D.P. ESTATES SUBDIVISION

Engineering Comments: **FINAL PLAT COMMENTS** (should be addressed prior to submitting the FINAL PLAT for review and/or signature by the City Engineer):

APPLICATION NUMBER 6 DATE October 7, 2021

DETAIL SITE PLAN

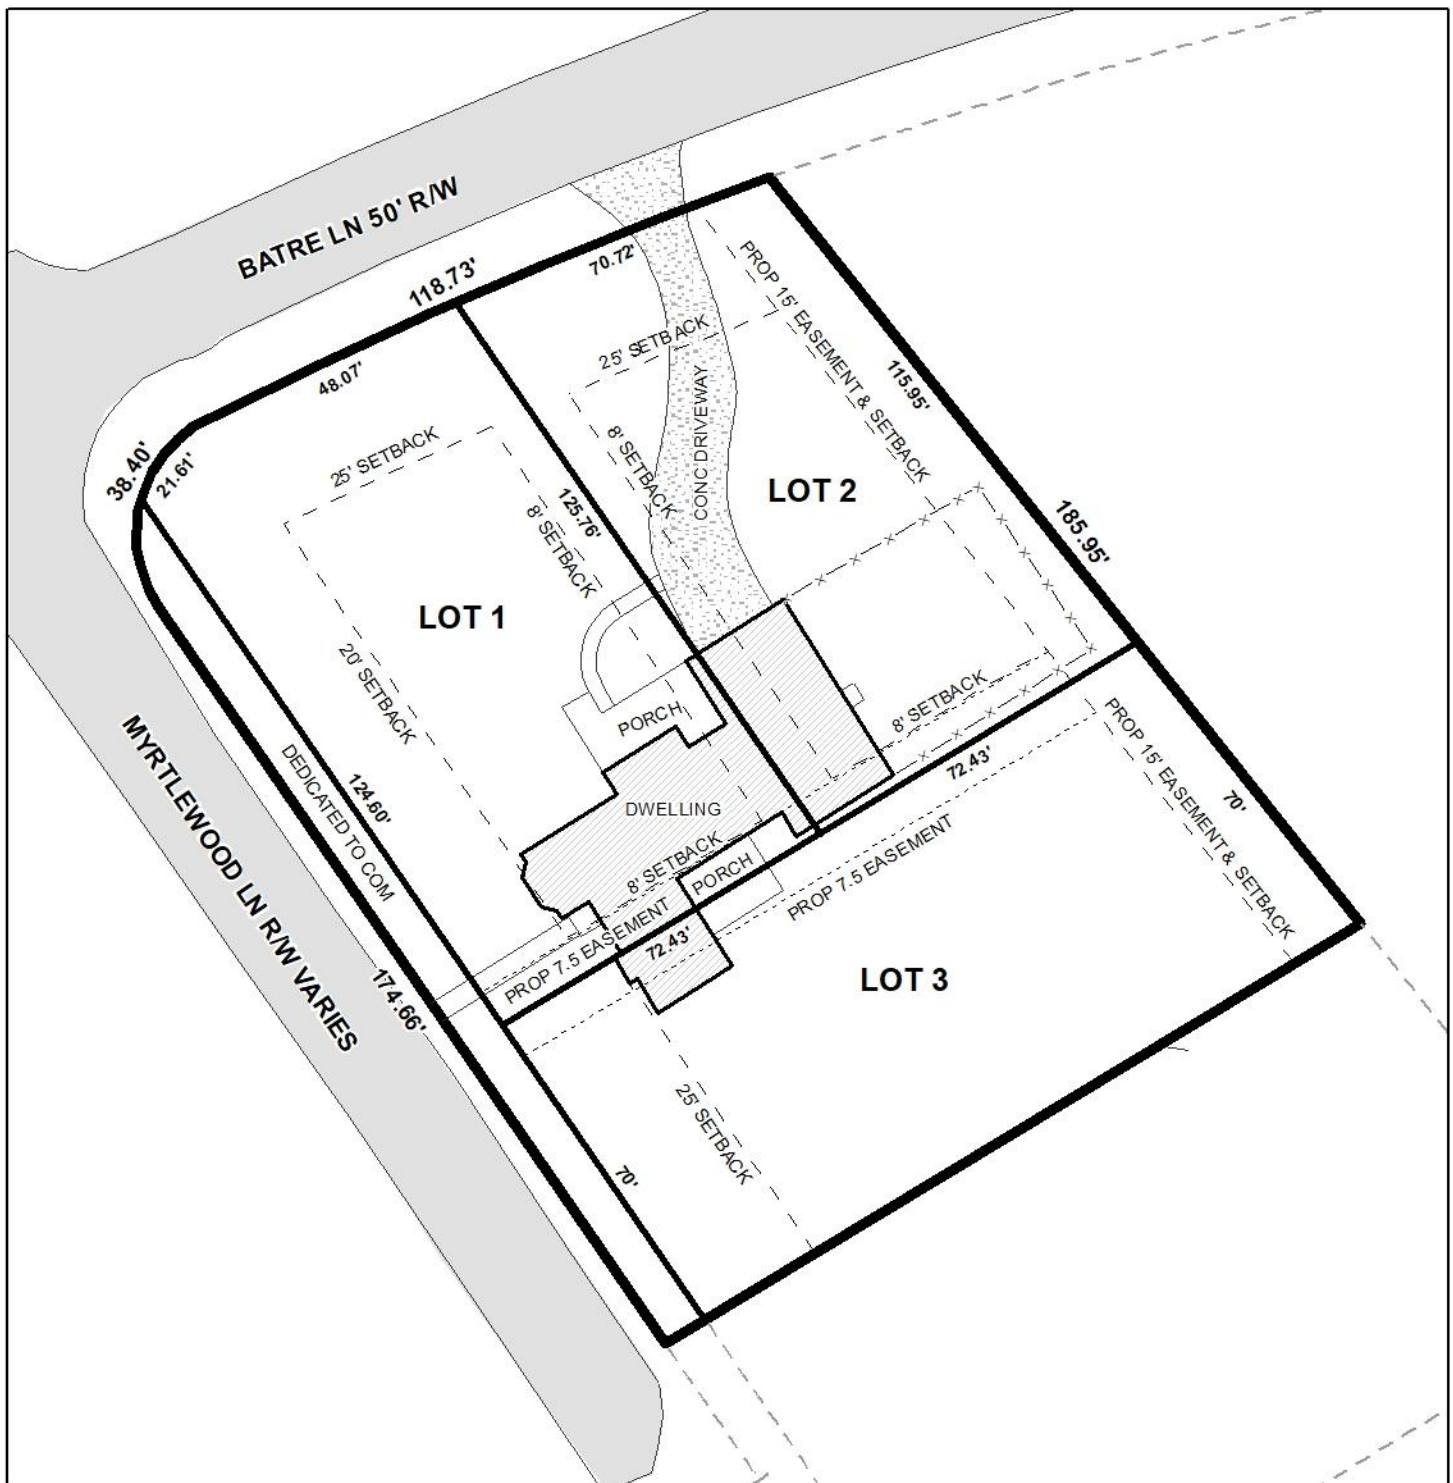
As stated previously, the purpose of the request is to subdivide one (1) metes-and-bounds parcel into three (3) legal lots of record. As proposed; Lot 1 is a corner lot with frontage along both Batre Lane and Myrtlewood Lane; Lot 2 has frontage along Batre Lane; and Lot 3 fronts Myrtlewood Lane. Both Batre and Myrtlewood are minor streets with curb and gutter requiring a minimum 50-foot right-of-way width. As illustrated, the preliminary plat shows a compliant right-of-way width for Batre Lane and dedication such to provide 25 feet from the centerline of Myrtlewood Lane. However, the preliminary plat also labels the right-of-way width for Myrtlewood as “Varies”, and as such, should be revised on the Final Plat to illustrate the required 25 feet of right-of-way from the centerline.

It is important to note that additional dedication may be required such to provide a compliant curb radius at the southeast corner of the intersection of Myrtlewood Lane and Batre Lane and should be revised on the Final Plat, adjusting dimensions and setbacks accordingly. It should also be noted that with any required dedication all proposed lots will still comply with the minimum size requirements of the Subdivision Regulations.

Currently, the subject site contains a 2,854± square-foot single-family dwelling centered on the existing site. As illustrated, the proposed interior lot line shared by Lot 1 and 2 would bisect the dwelling placing a significant portion of the structure on each proposed lot. A smaller portion, approximately 340± square feet, would be located on the proposed Lot 3. In order to avoid the need for variances the existing dwelling should be removed via a demolition permit prior to signing the Final Plat.

The preliminary plat indicates proposed 7.5-foot drainage easements along interior lot lines as well as a proposed 15-foot drainage easement along the eastern lot lines of Lots 2 and 3. Therefore, a note should be required on the Final Plat stating that no structure may be constructed or placed within any easement without the permission of the easement holder.

- 1) revision of the Final Plat to label the right-of-way width for Myrtlewood Lane as 25 feet from the centerline as well as any required dedication;
- 2) provision of adequate dedication to provide compliant curb radii at the southeast intersection of Batre Lane and Myrtlewood Lane, adjusting lot dimensions and setbacks accordingly;

- 3) retention of the right-of-way width for Batre Lane on the Final Plat;
- 4) retention of the 25-foot minimum building setback line on the Final Plat, adjusted for any required dedication;

- 5) retention of the lot size labels in both square feet and acres on the Final Plat, or the furnishing of a table on the Final Plat providing the same information;

- 6) placement of a note on the Final Plat stating that no structure may be constructed or placed within any easement without the permission of the easement holder;

- 10) compliance with the Fire Department comments: *(All projects within the City Limits of Mobile shall comply with the requirements of the City of Mobile Fire Code Ordinance (2012 International Fire Code). Fire apparatus access is required to be within 150' of all commercial and residential buildings. A fire hydrant is required to be within 400' of non-sprinkled commercial buildings and 600' of sprinkled commercial buildings.);* and
- 11) removal, via a demolition permit, of the existing dwelling prior to signing the Final Plat.
